DESIGN REVIEW COMMITTEE MEETING

4.I. 3637 Elm Street Addition

4.II. 3558-3668 Elm Street New Multi-Family Construction

DEPARTMENT OF PLANNING AND ZONING
PLANNER'S REPORT

EXISTING FOUNDATION - PLAN & DETAILS
SCALE: 1/4"=1'-0"

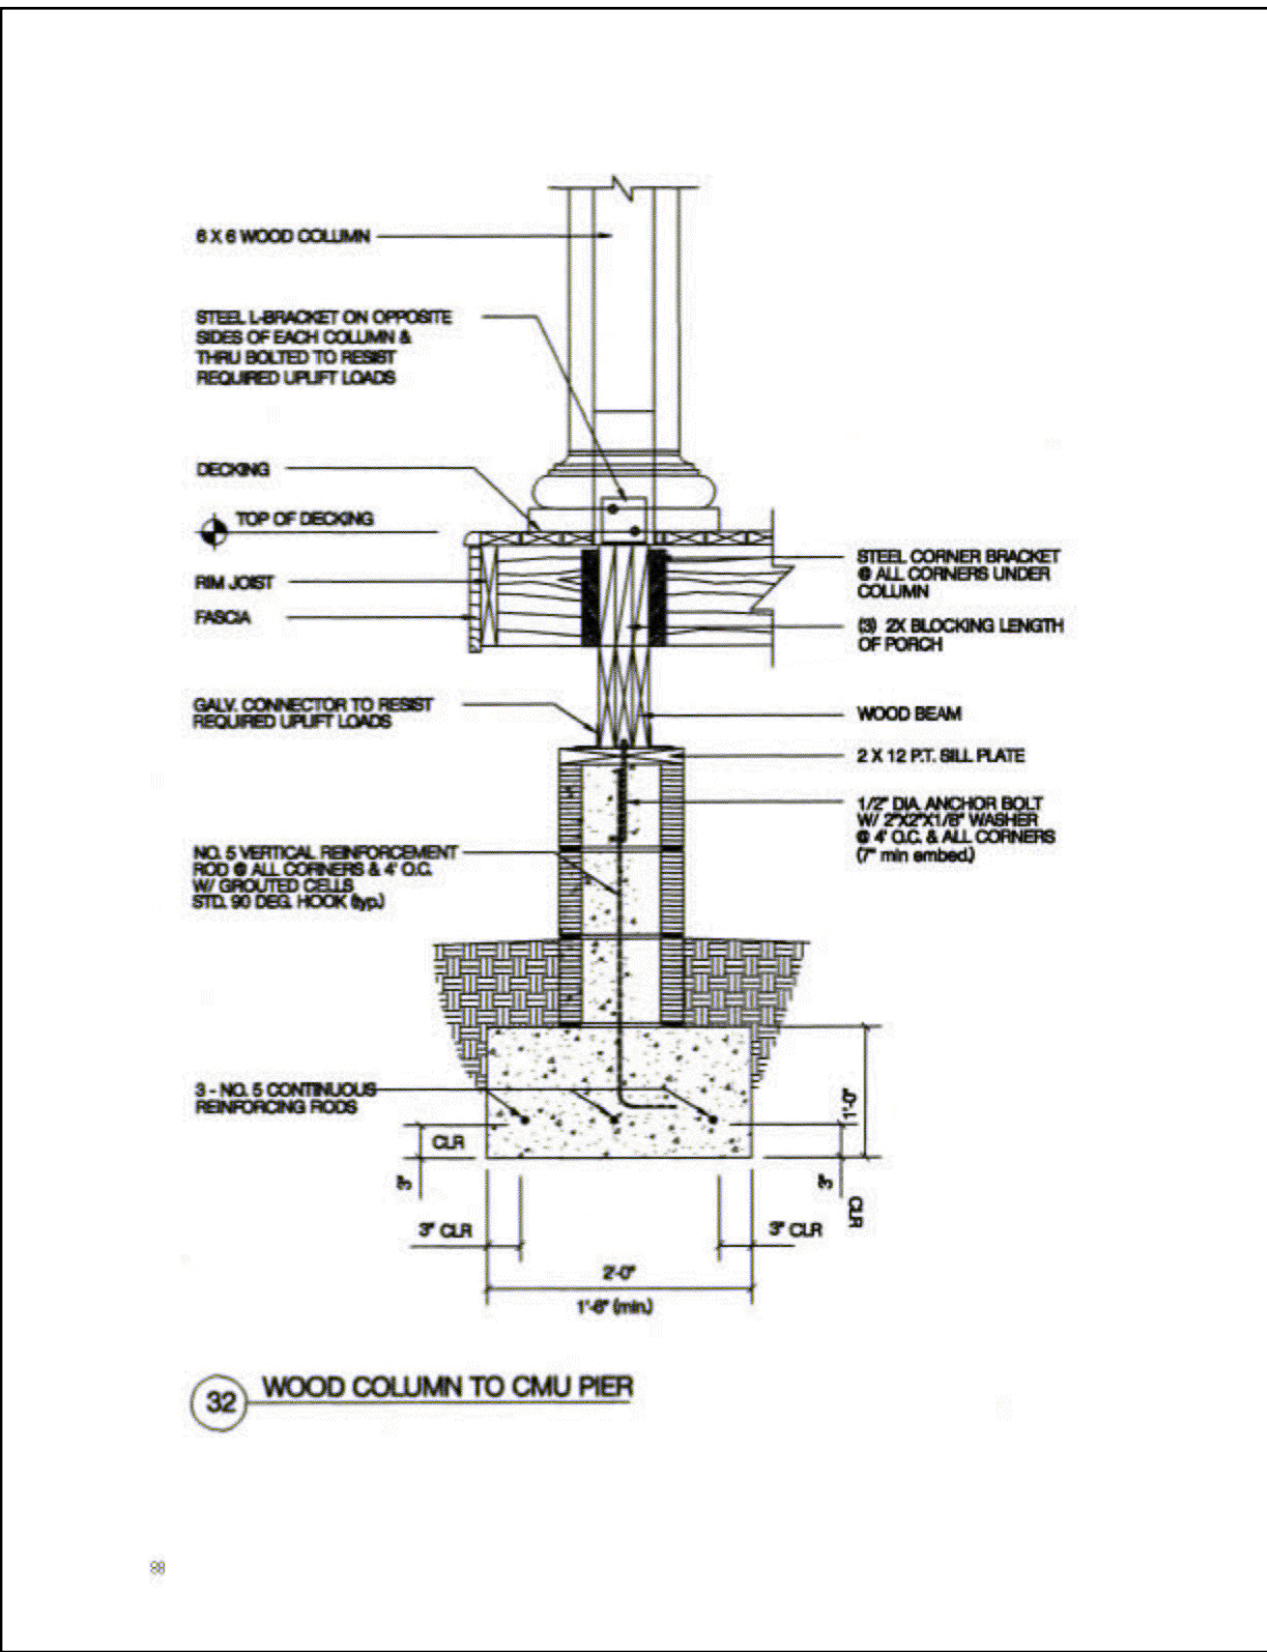
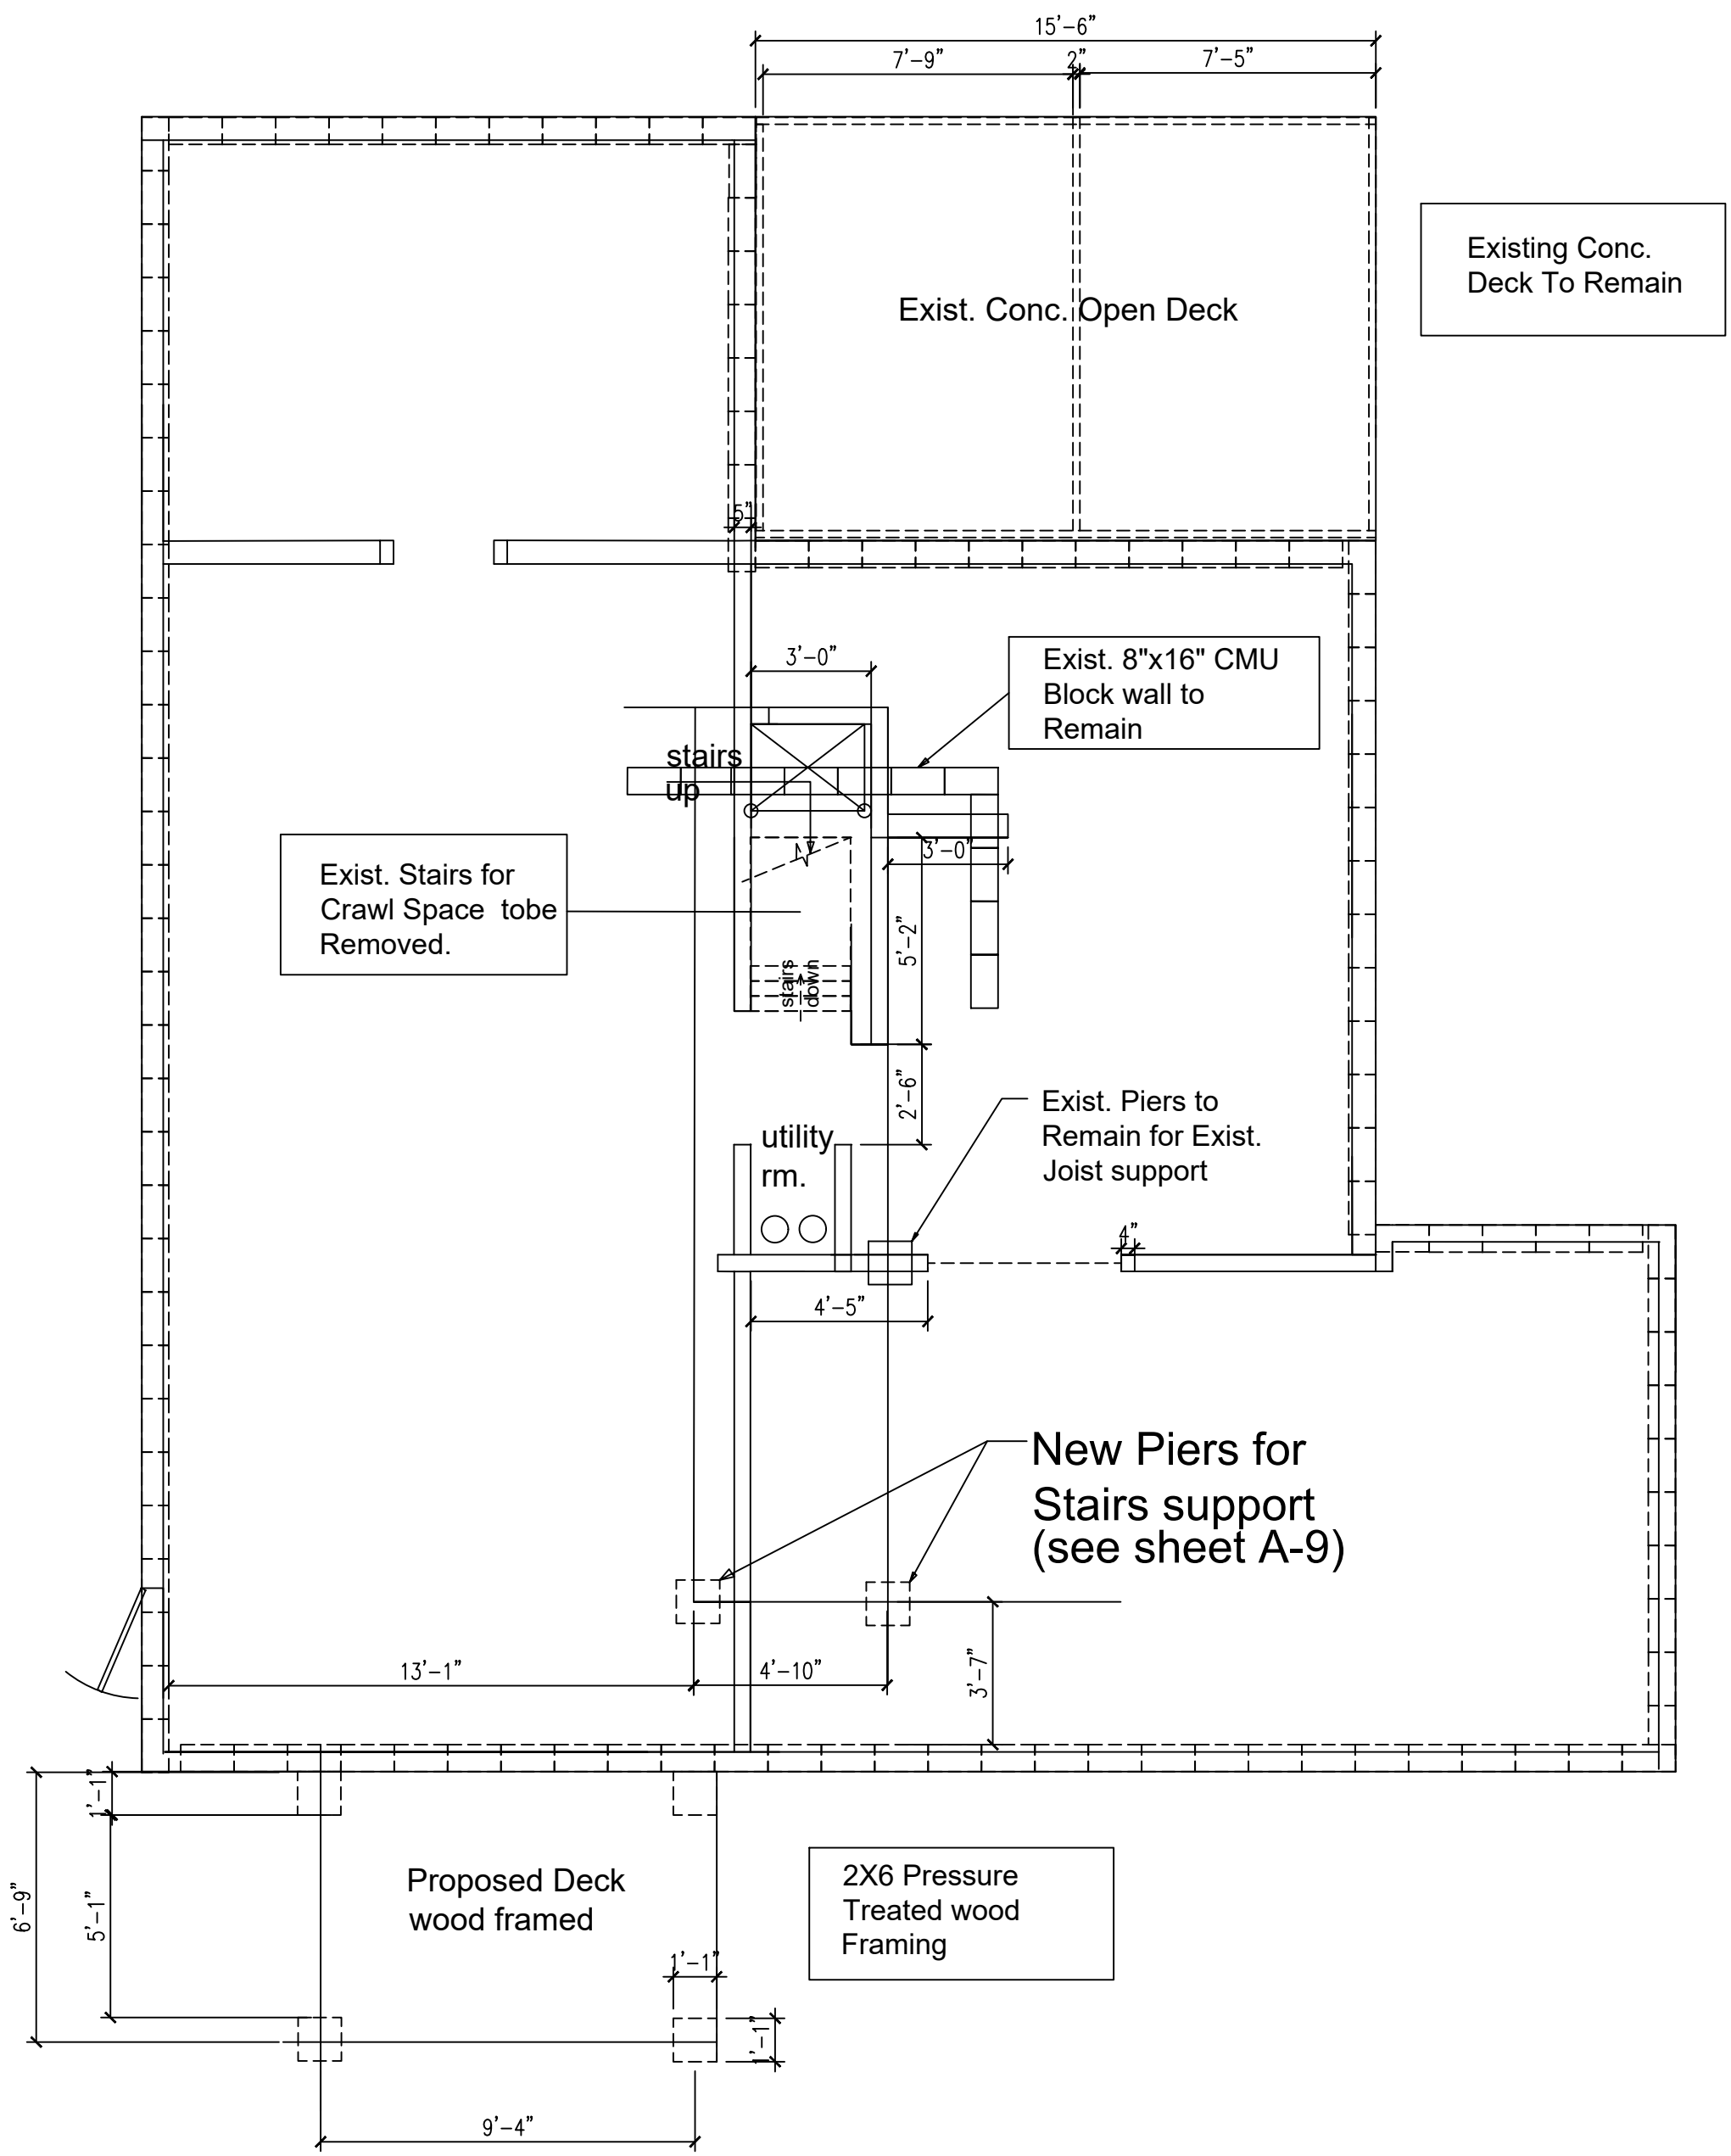
The New Deck will not be added
